Connah's Quay Low Carbon Power

Consultation Report: Appendix G Targeted Consultation

Document Reference: EN010166/APP/5.2

Connah's Quay Low Carbon Power
Targeted consultation on changes to our proposals
Thursday 8 May to Friday 6 June 2025

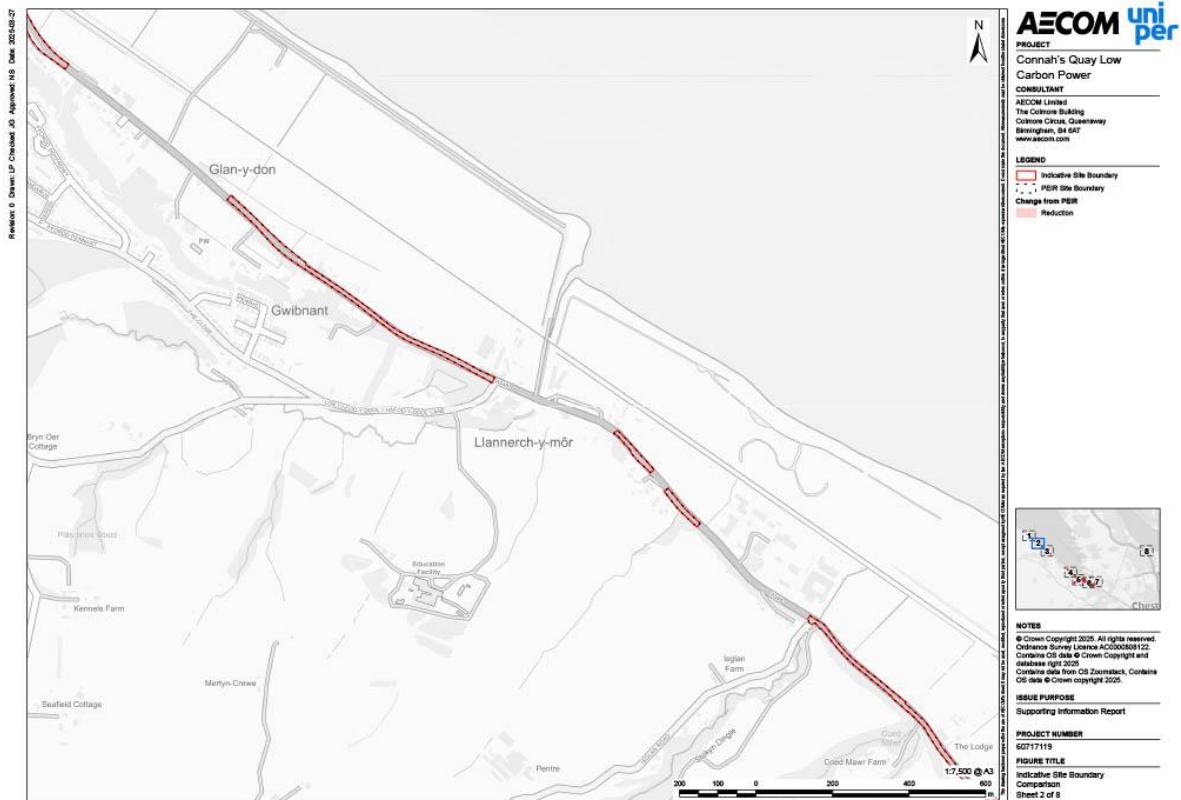
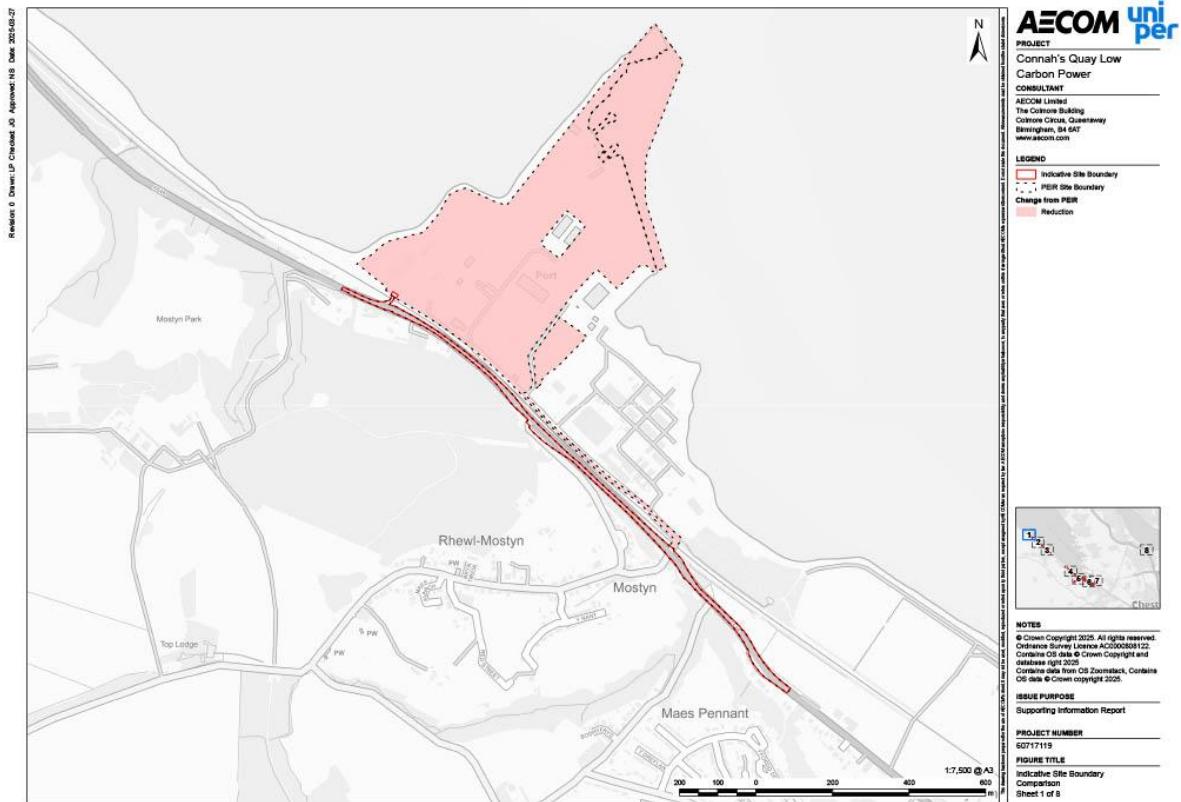
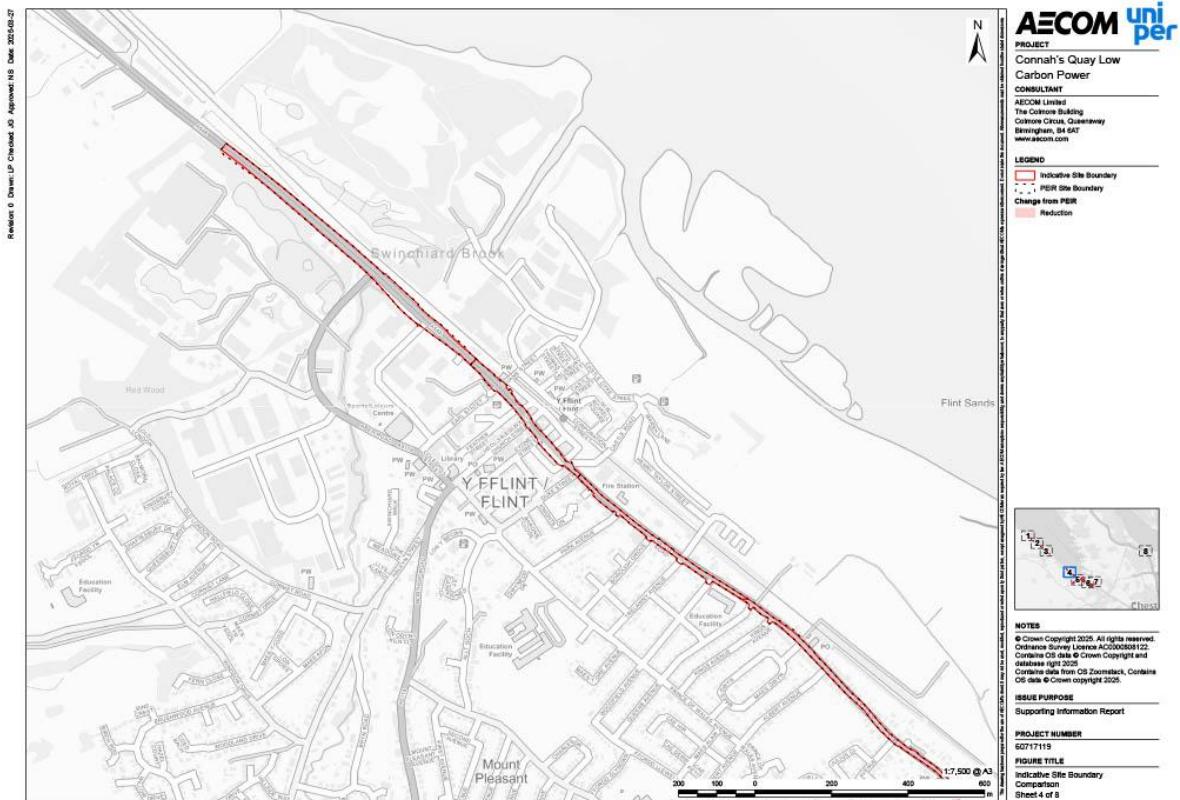
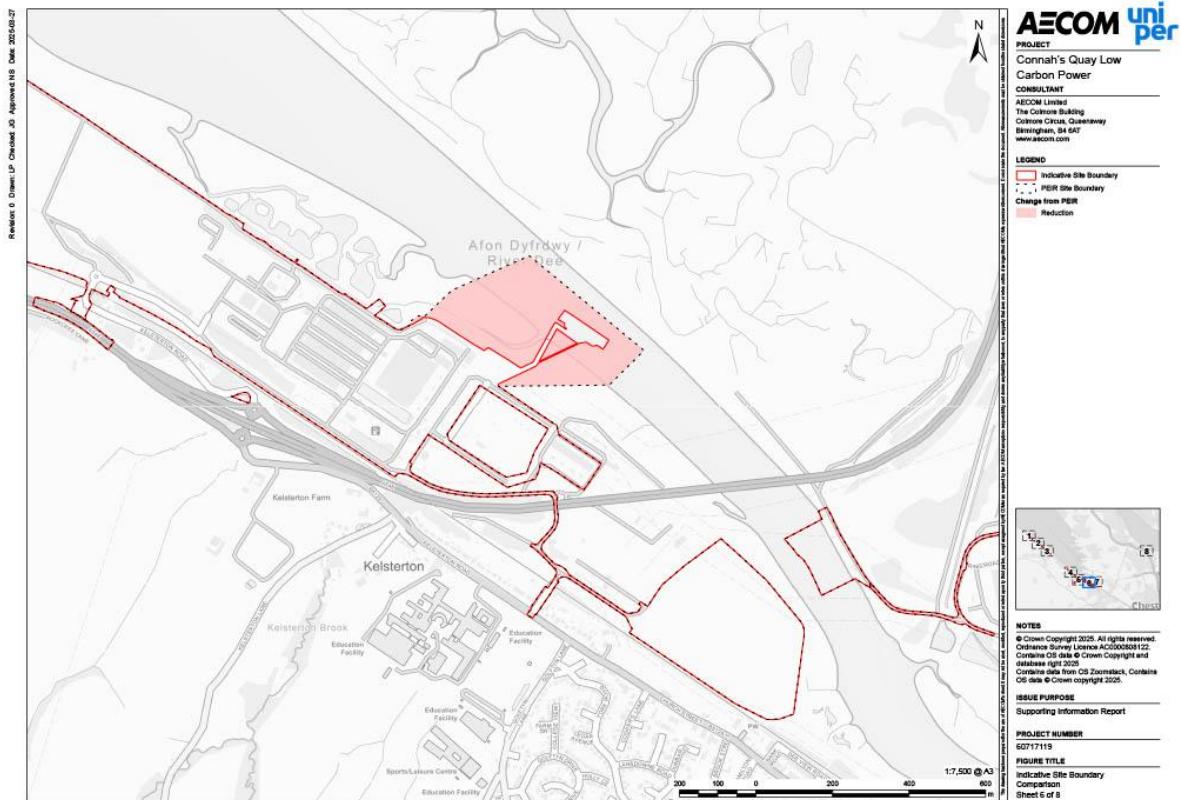
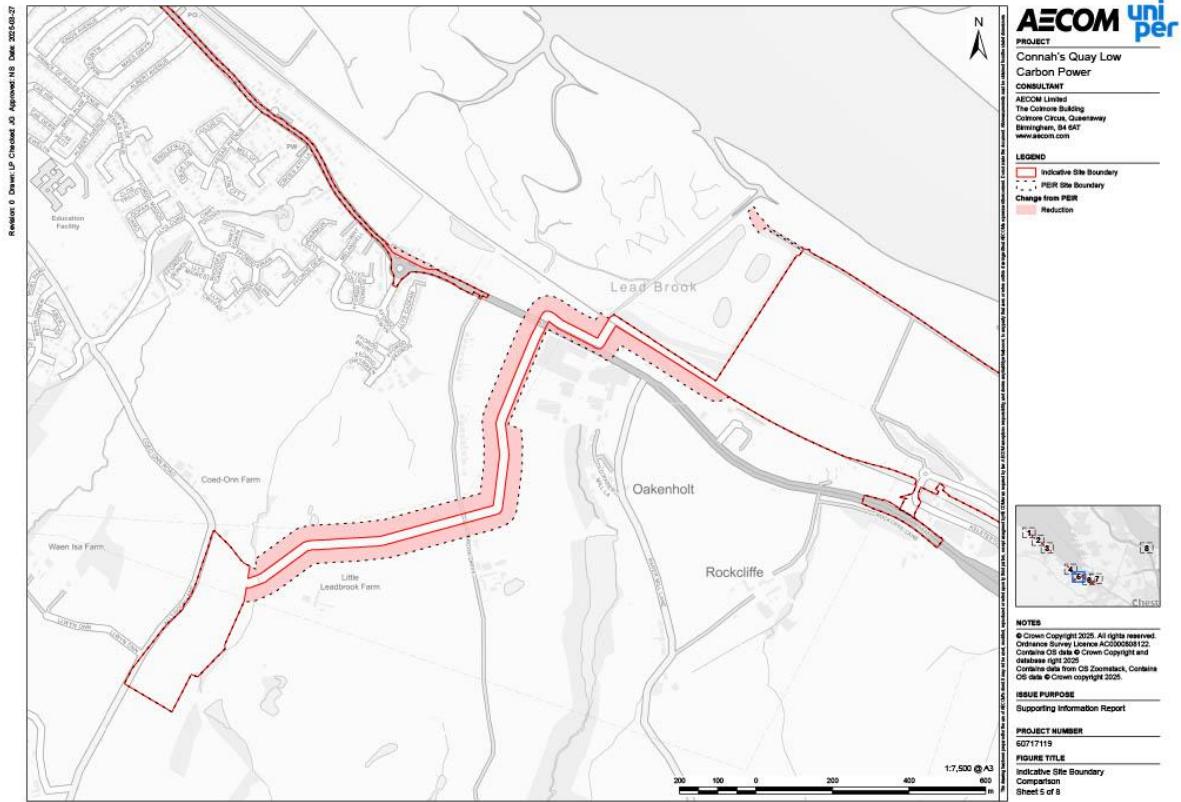
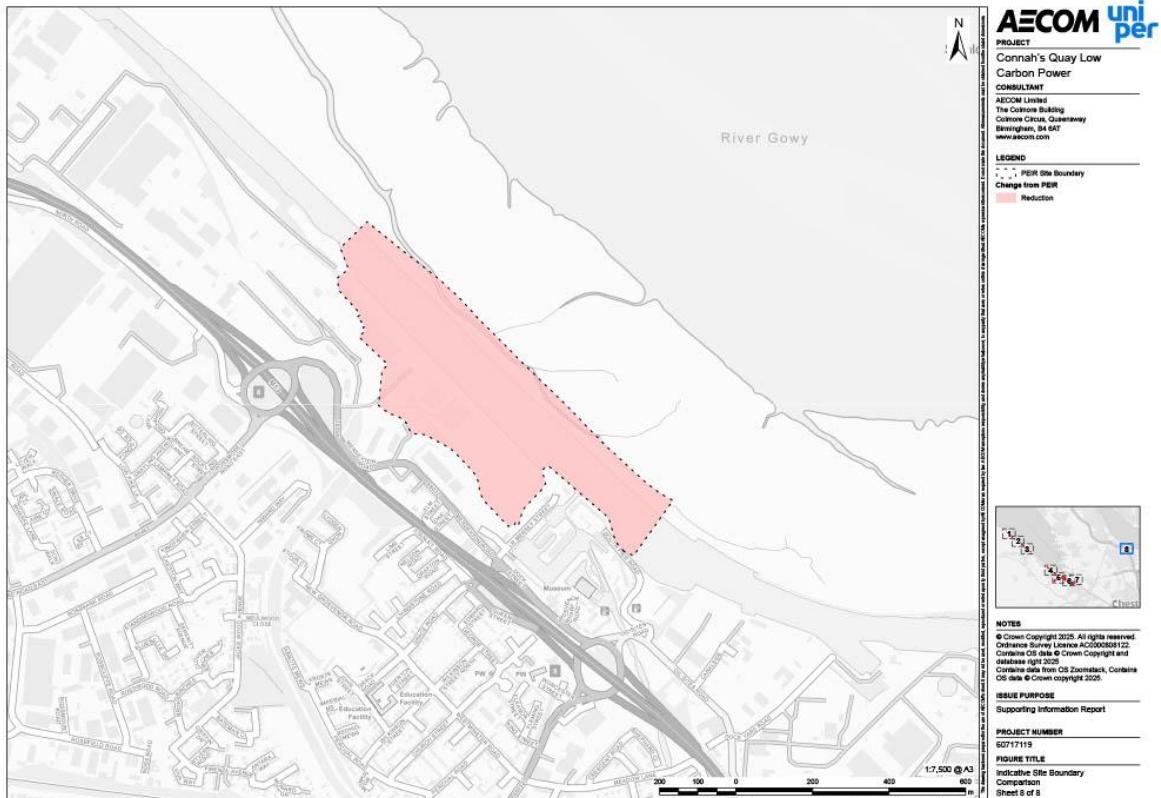
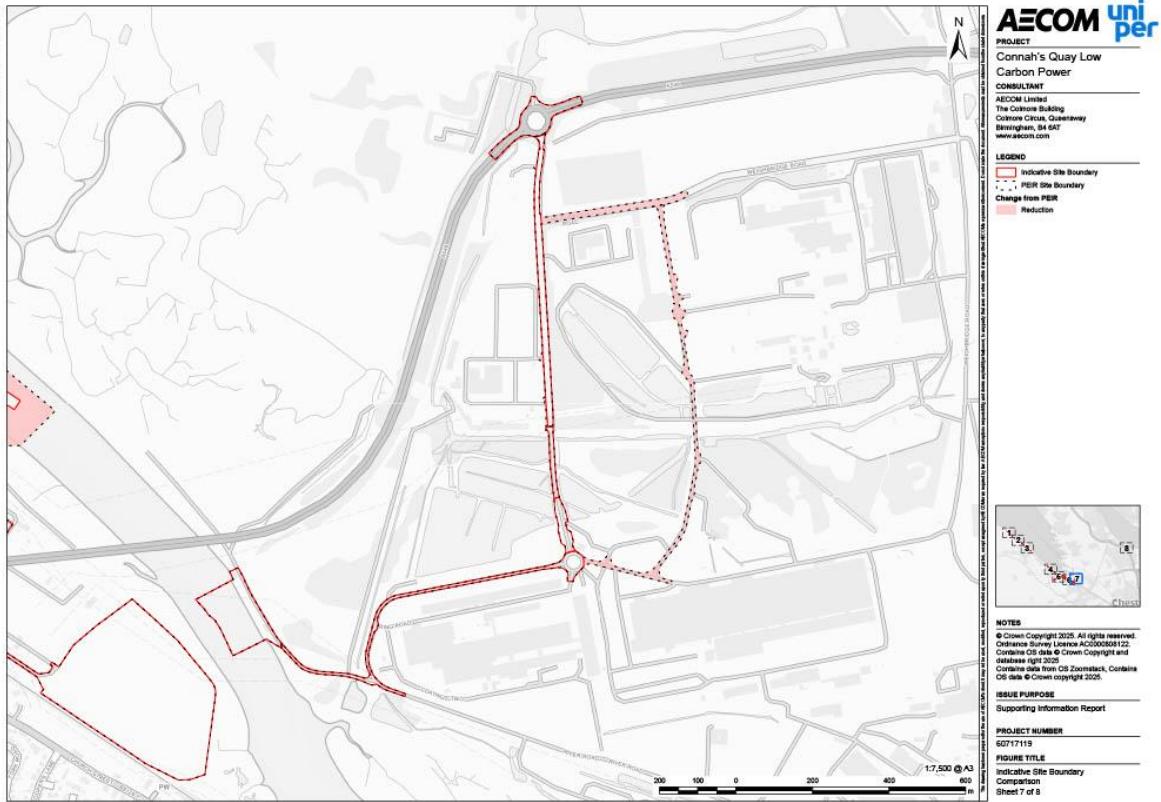
4.1.2 Following further design development and environmental assessment, eight changes have been made to the design of the Proposed Development. These are discussed in further detail below and the locations are shown on **Figure 6**.

4.1.4 Following further technical studies, technology providers confirmed that each CCGT train can be served by a single CCP, reducing the complexity of the plant required to be provided.

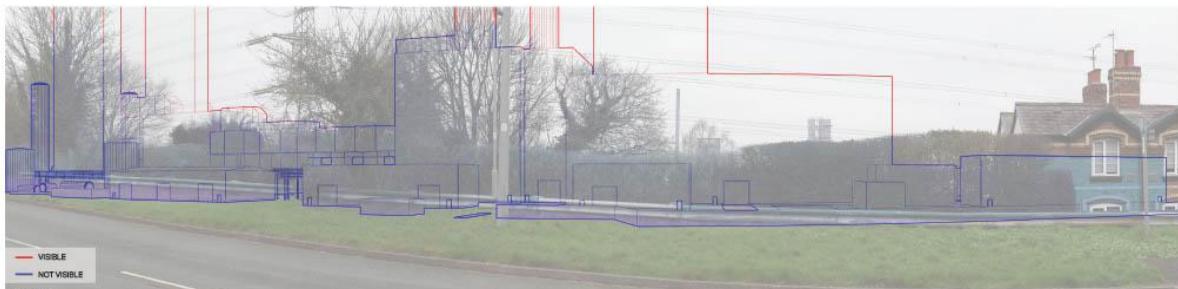
- Viewpoint 10 (Kelsterton Road, Rockcliffe) - there would be a change in view and effects would be an increase from moderate adverse (significant) to major adverse (significant).

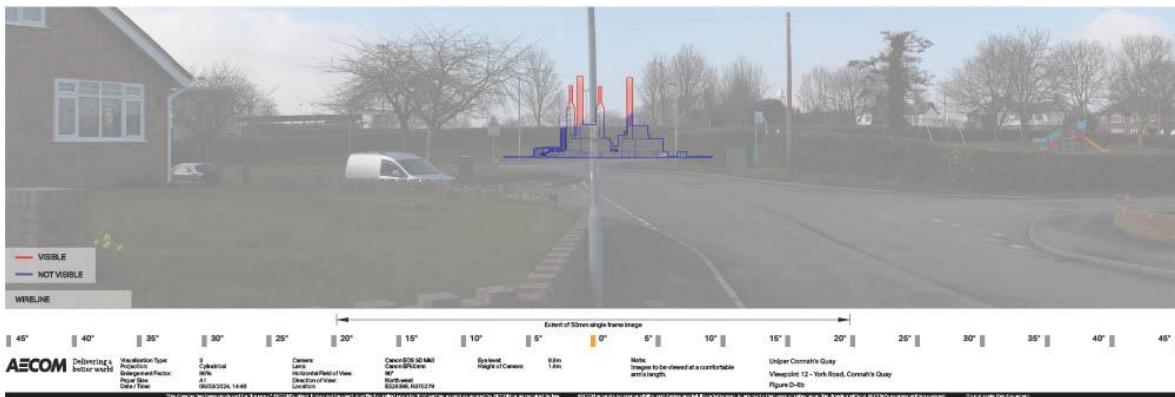
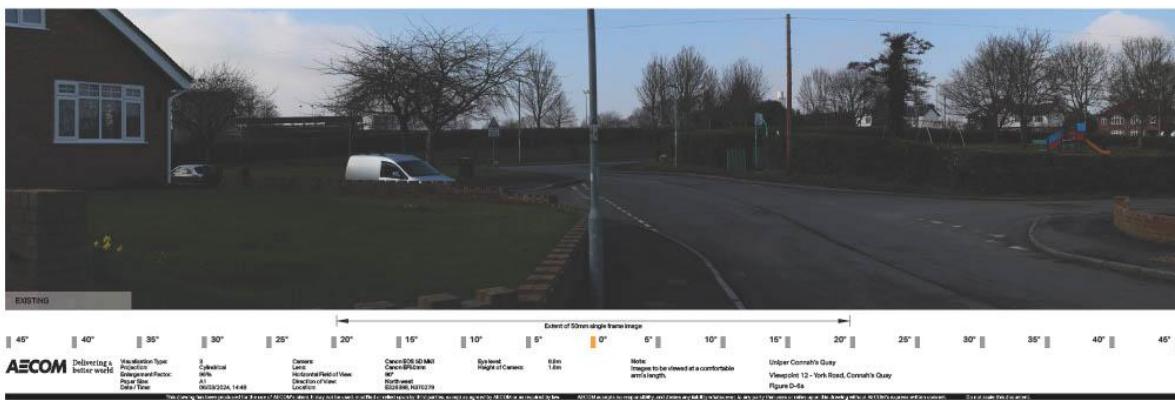
- Viewpoint 11 (Kelsterton Cemetery, Rockcliffe) - there would be change in view however there would be no change to the assessment findings presented in the PEIR and effects would remain moderate adverse (significant).
